**Restoration Services and Painting Project
Addendum #2 - May 28, 2024**

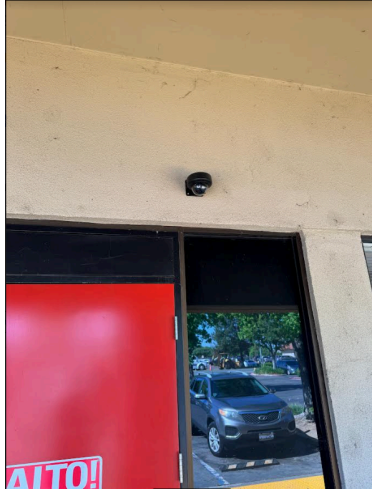
1. Is the Allowance on the Bid Lump Sum or Percentage? If not specified then all bids will not be equal and fair. **The allowance is not a percentage, please see the bid form. The total bid will include allowances.**
2. Can you please specify the 14-LED exterior lights so that we are all on the same page in the bidding process? **PLATT - LED Wall Light, 10,000L, 4500K, 82W, Item #: 1607657, Cat #: WD10L45K, UPC: 765364940804**
3. Will we require temporary lighting during construction when building lighting is removed?
Yes
4. Is this the spot that was requested for us to repair? **Yes, 20x20 sq.ft. of roof needs to be built up on south side of roof above back entrance and electrical closet.**
